Subject: Duke Energy Carolinas, LLC
William States Lee III Nuclear Station - Docket Nos. 52-018 and 52-019
AP1000 Combined License Application for the
William States Lee III Nuclear Station Units 1 and 2
Response to Request for Additional Information
Ltr# WLG2010.07-08

Reference: Letter from Sarah Lopas (NRC) to Bryan Dolan (Duke Energy), Request for
Additional Information Regarding the Supplement to the Environmental Report
for the William States Lee III Nuclear Station, Units 1 and 2, Combined License
Application, dated June 22, 2010 (ML101370398)

Lee Nuclear Station Response to Request for Additional Information (RAI)

Figure 1. 2234 MW Combined Cycle Plant Water Usage Impact on Water Surface Elevations of Make Up Ponds with Refill from the Broad River (83-year record) and Future Water Demands

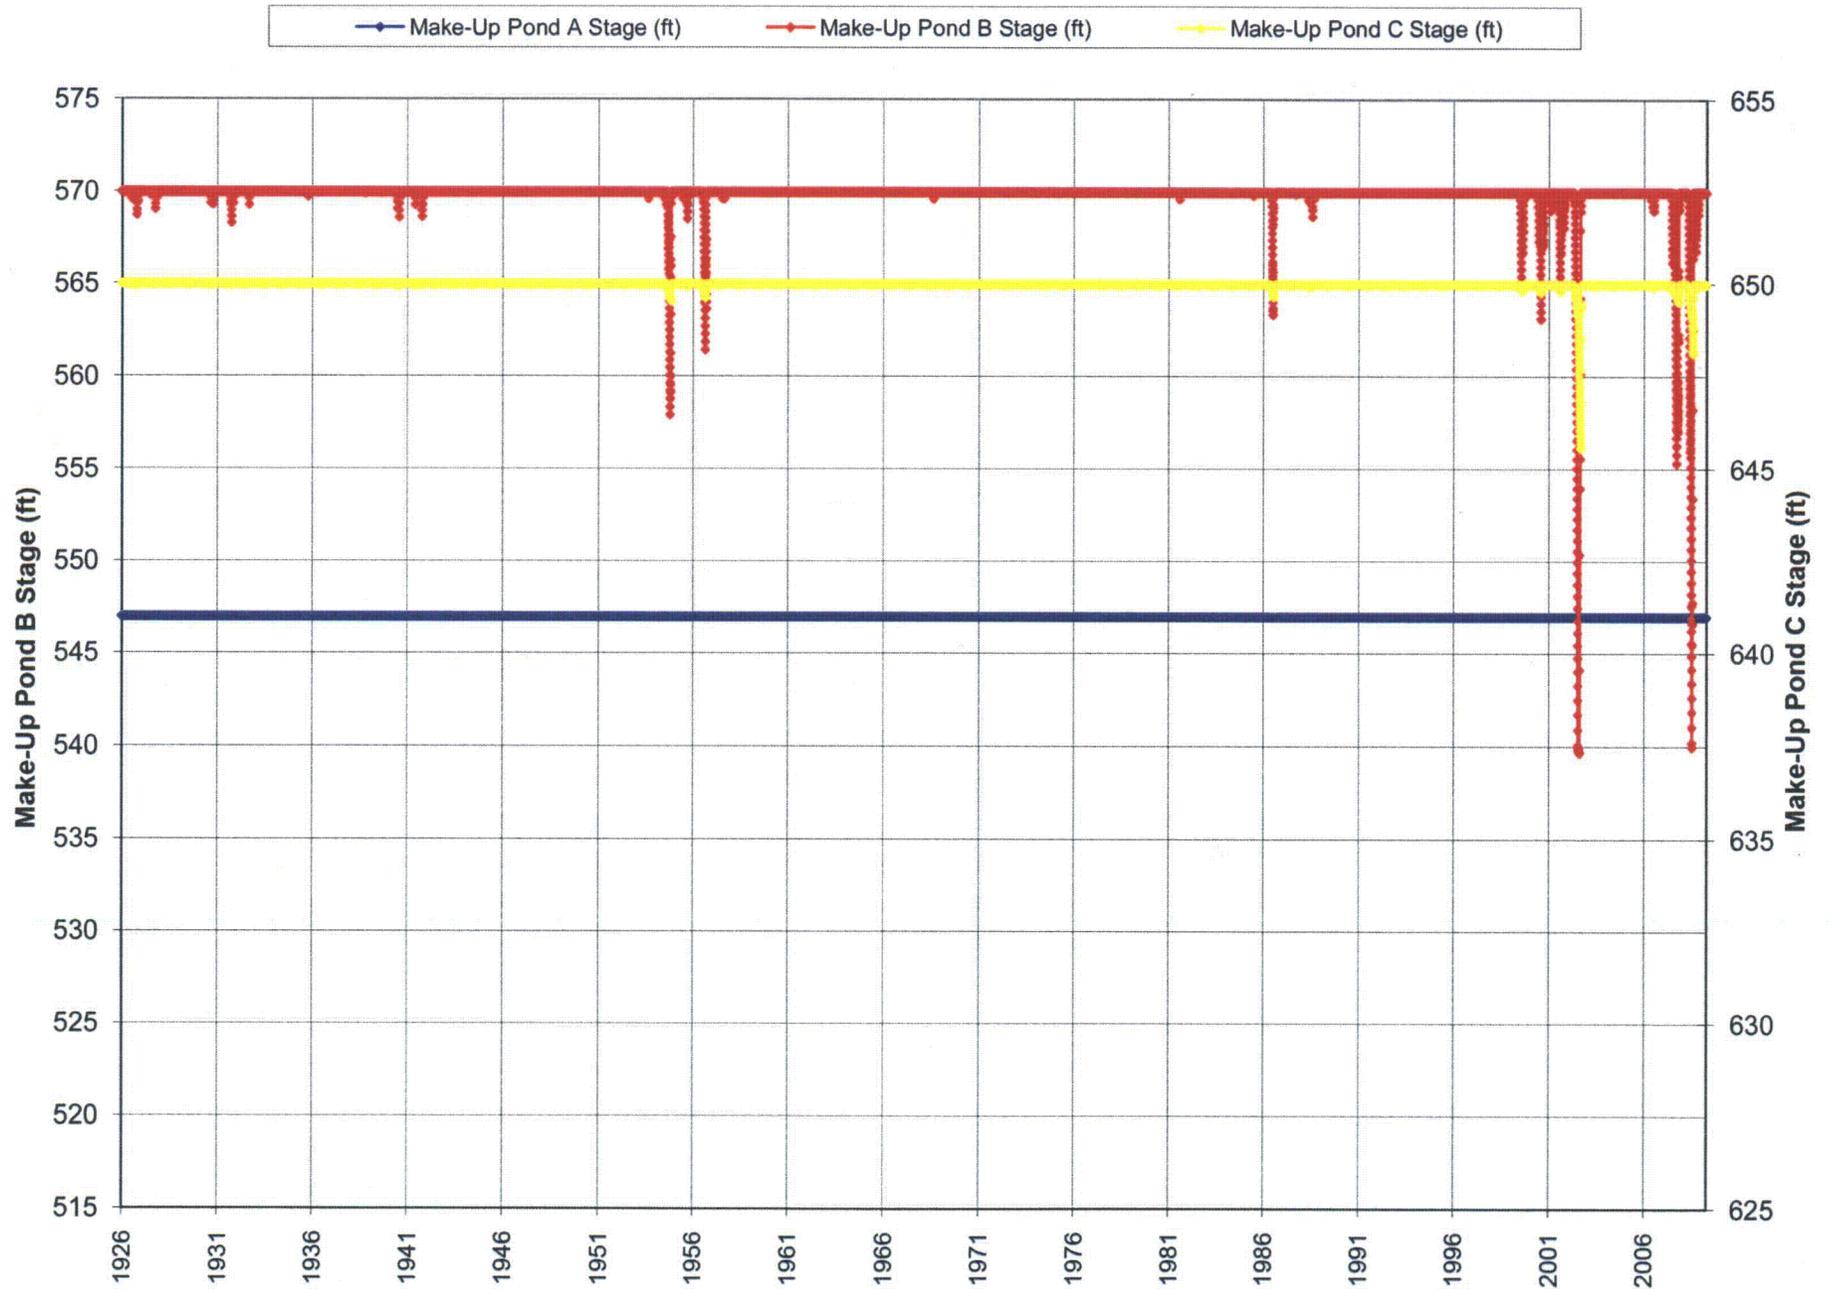
Provide additional details for the Alternative Energy analysis at the Lee Nuclear Station regarding consumptive make-up water requirements for a combined cycle natural gas-fired power plant. Specifically, provide analysis to describe whether Pond C would be required for this alternative.

The results of the water balance model run using the monthly average consumptive water use for a similar-sized combined cycle unit(s) are provided graphically in Figures 1 through 4. Figure 1 shows drawdowns in Make-Up Pond B and Make-Up Pond C for the simulated 83-year period of record. Figures 2, 3, and 4 show periods of significant drawdown from 1954 through 1956, 1999 through 2002, and 2007 through 2008, respectively.

The results of this evaluation demonstrate that Make-Up Pond C would be needed to provide make-up water for a combined cycle natural gas-fired power plant located on the site of the proposed Lee Nuclear Station. The use of Make-Up Pond C would have been needed for 37 days in 2002 and 9 days in 2008.

<p>WILLIAM STATES LEE III NUCLEAR STATION UNITS 1 & 2</p>
<p>River Water Intake Structure</p>
<p>FIGURE 5.3-1 - Sheet 1 of 2 Rev 2</p>

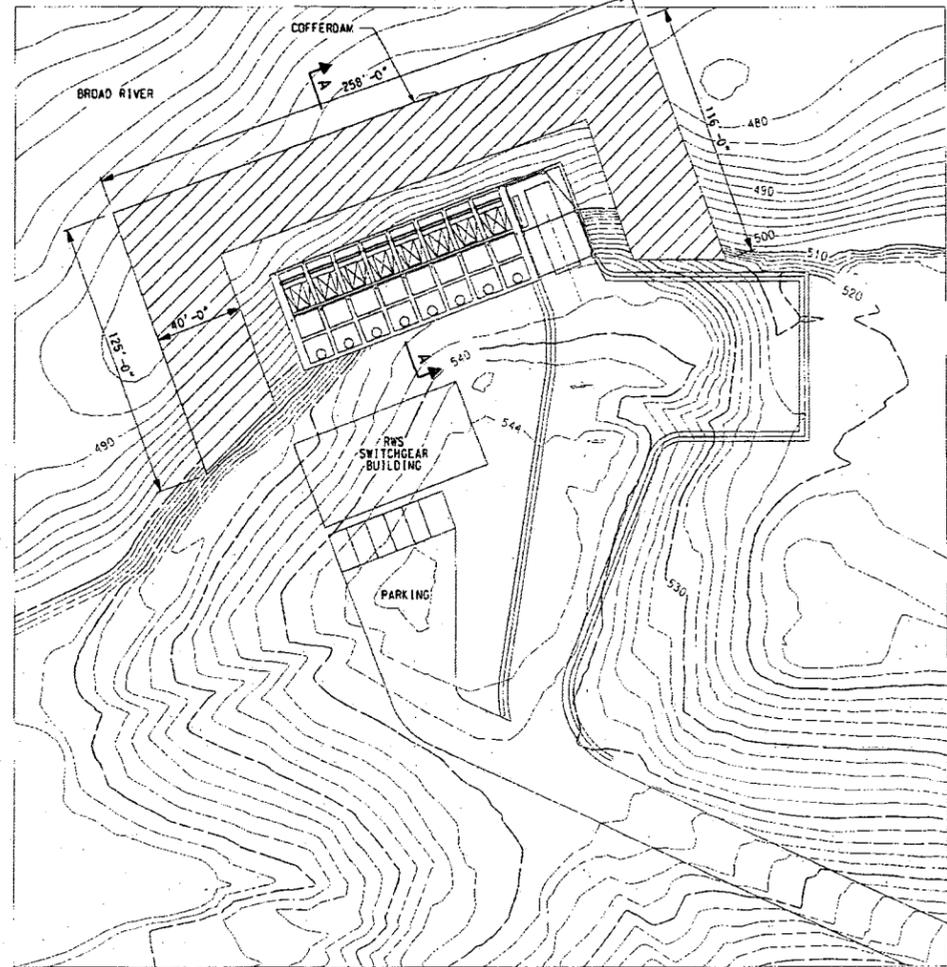
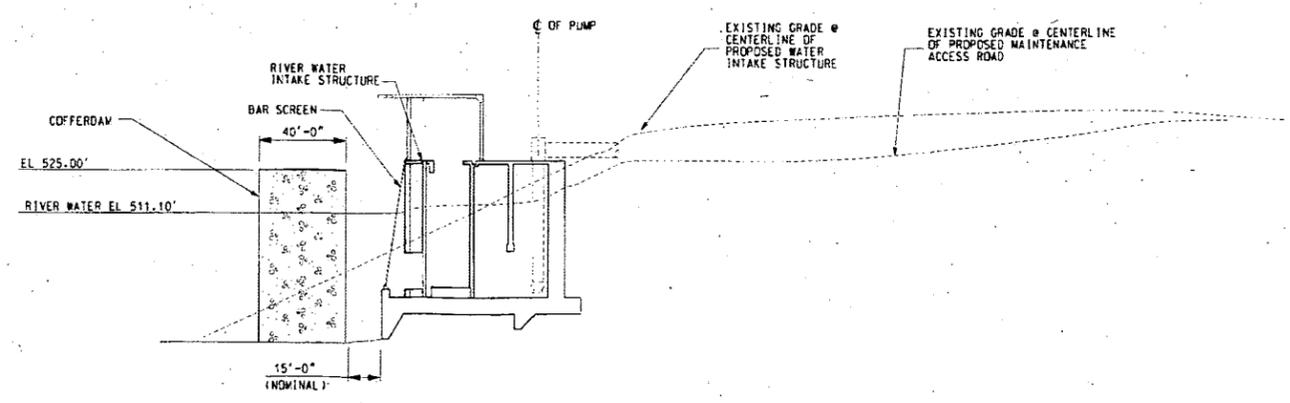
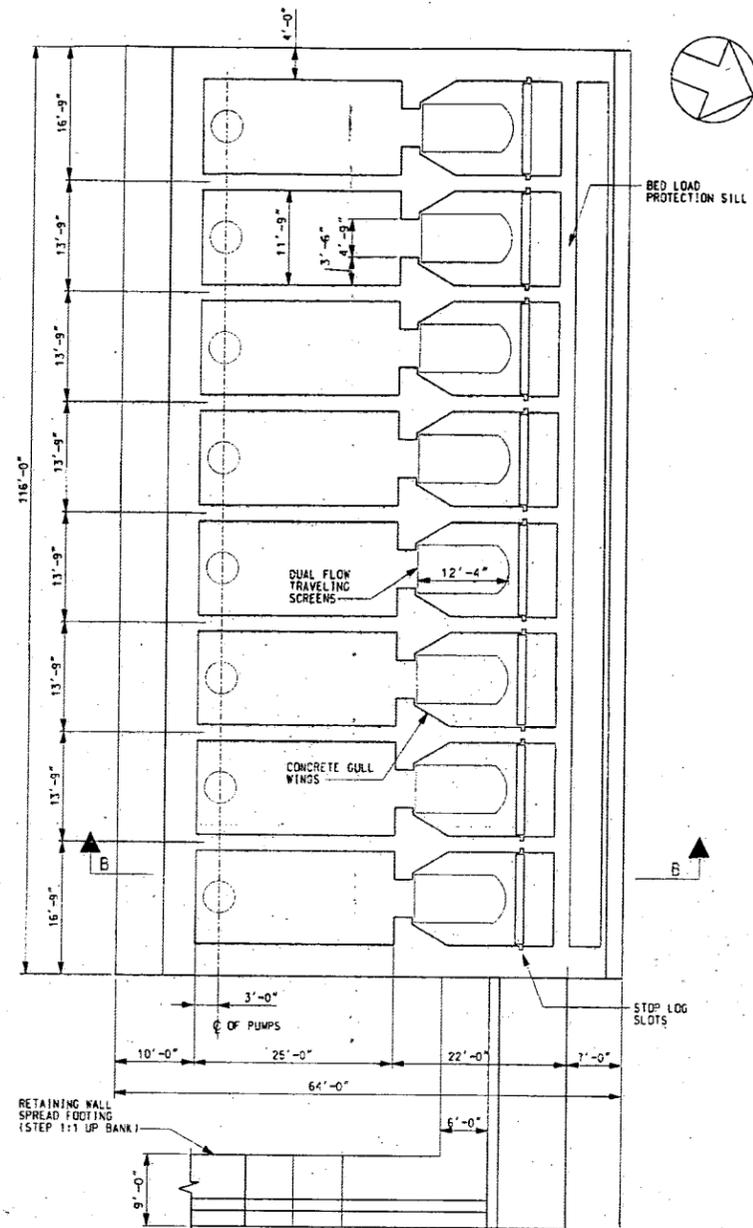
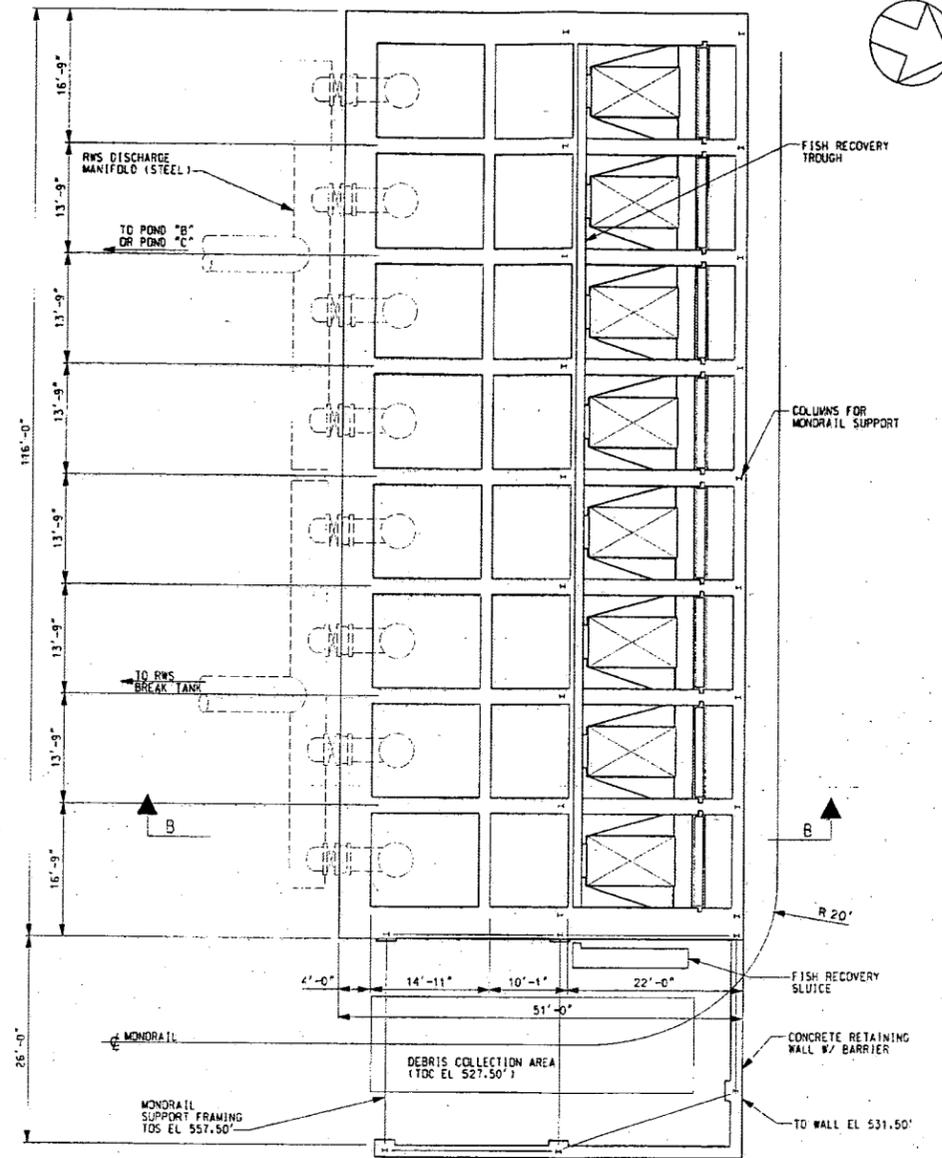
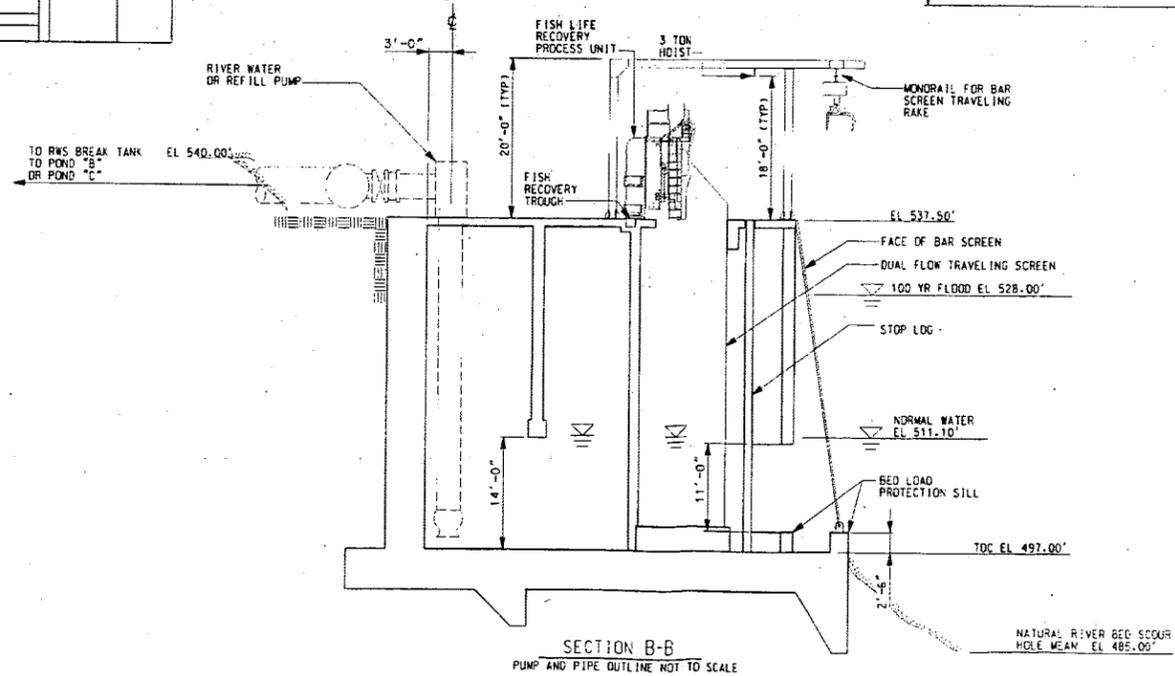
Provide physical descriptions (e.g., location, dimensions, construction materials, pump systems) of the "River Water Intake Subsystem" and the "Refill Subsystem Intake" referred to in Supplemental ER Figure 3.3-1, Sheets 1 and 2.

The river intake is a single intake structure with two sections. One section is for the river water subsystem and the other section is for the refill subsystem. Each section has four forebays with a total of eight forebays for the intake structure. Attachment 190-01 provides a revised ER Figure 5.3-1 which shows the dimensions of the river intake structure. Figure 4.2-2 in the ER
